Addendum # 3 -- 17-012.0-CIP -- E-Mail Coversheet

Limerick Lane Stormwater Improvements

ADDENDUM NO. 3
to the contract for

Limerick Lane Stormwater Improvements
17-012-CIP
Bid Opening Date: April 3, 2018

LIMERICK LANE PLAN & PROFILE

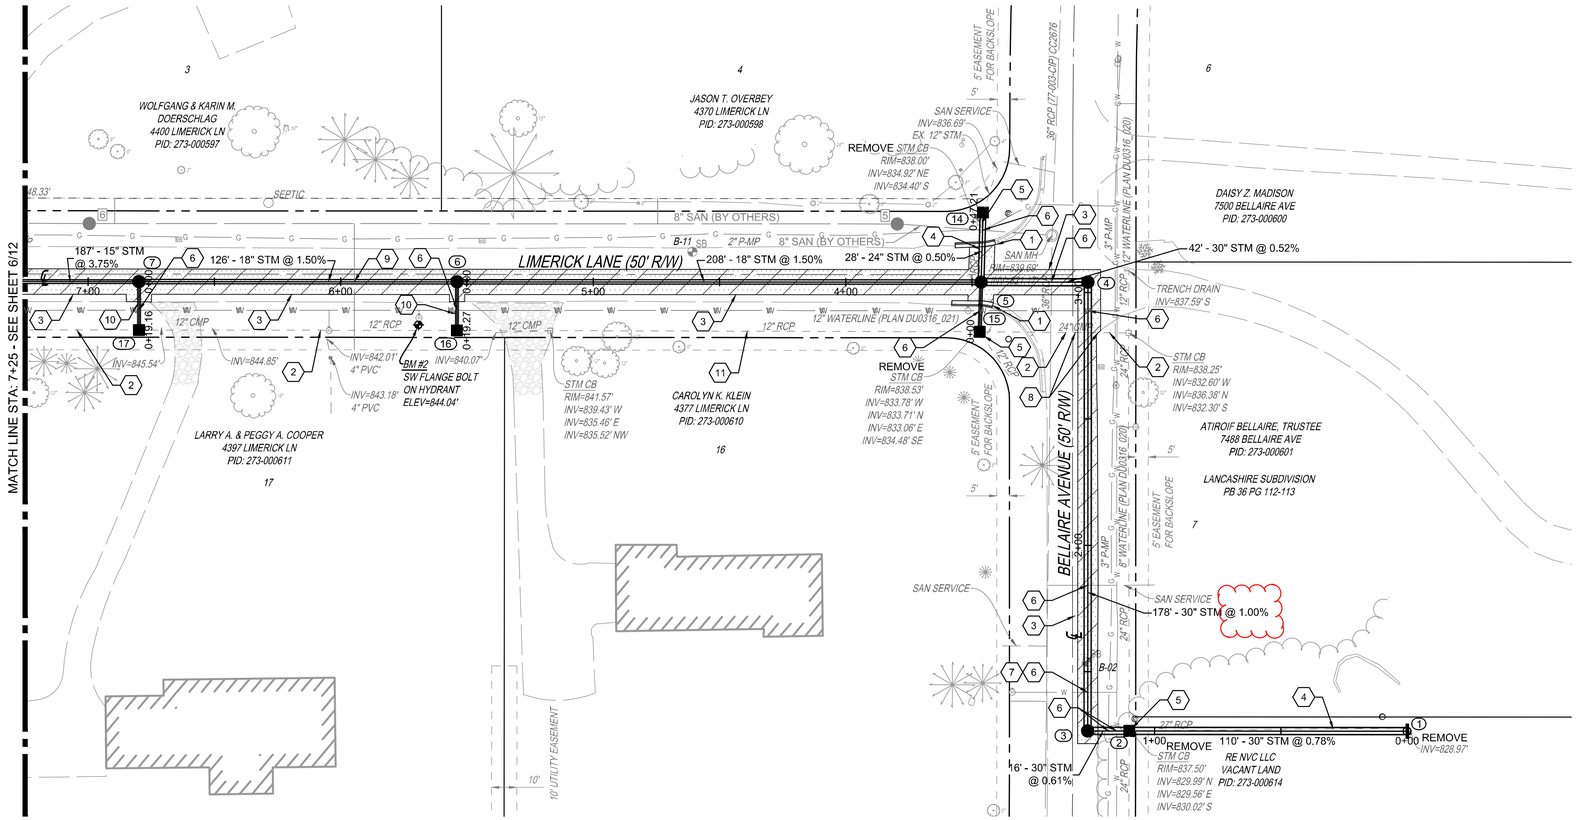
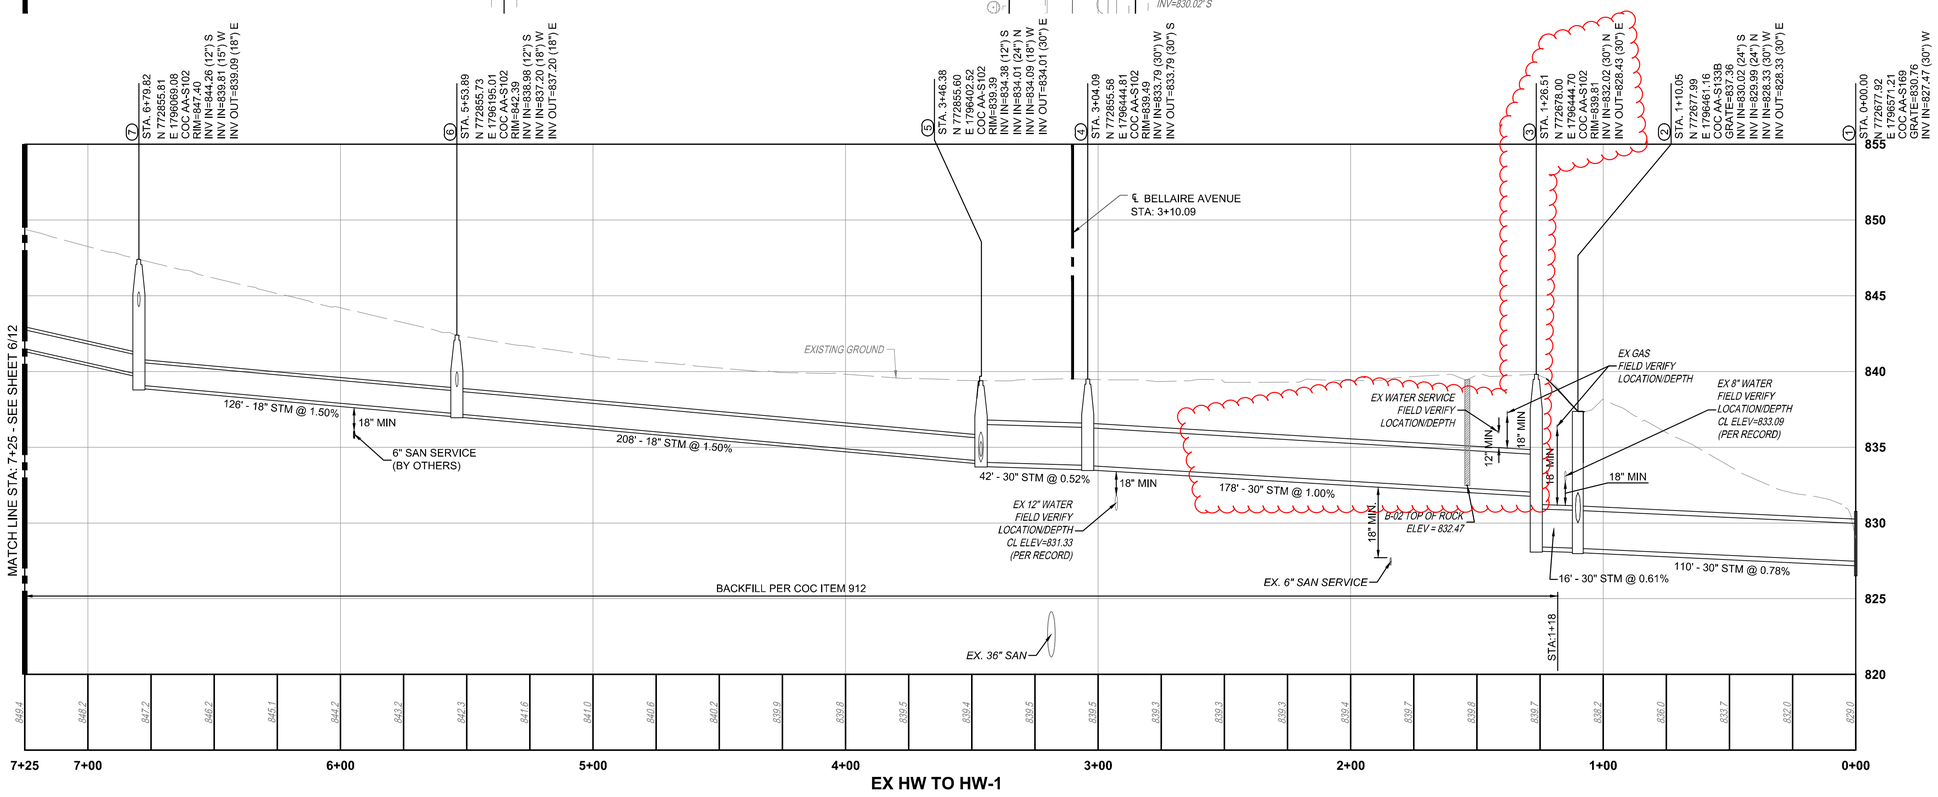
Sheet 7
Change: 178′ of 30″ STM @ 0.53%
To: 178′ of 30″ STM @ 1.00%

STORM SEWER PROFILES

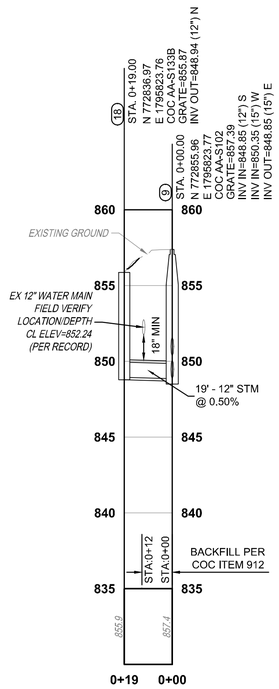
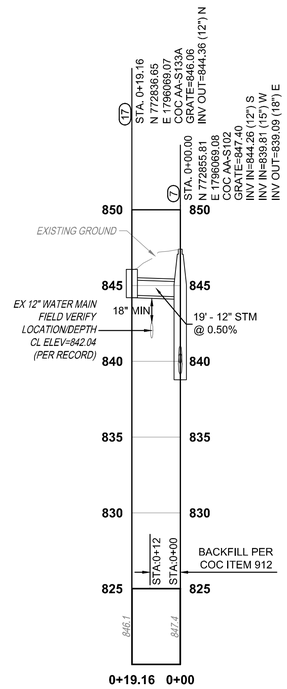
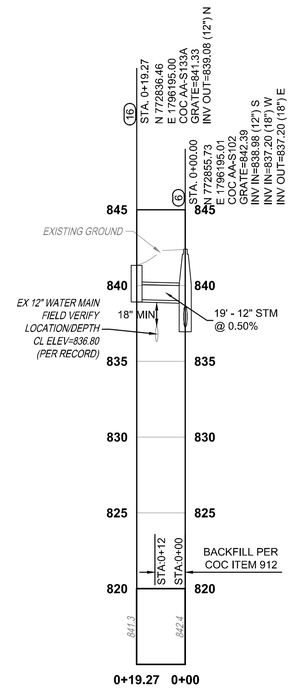
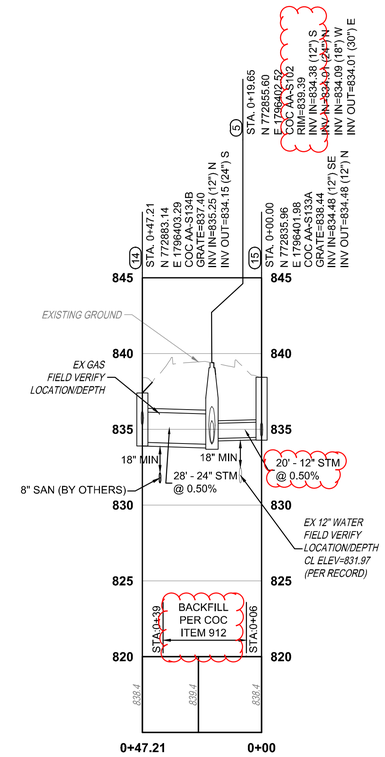
Sheet 8
Change: 20′ of 12″ STM @ 0.00%
To: 20′ of 12″ STM @ 0.50%

Change: Backfill Per COC Item 613
To: Backfill Per COC Item 912
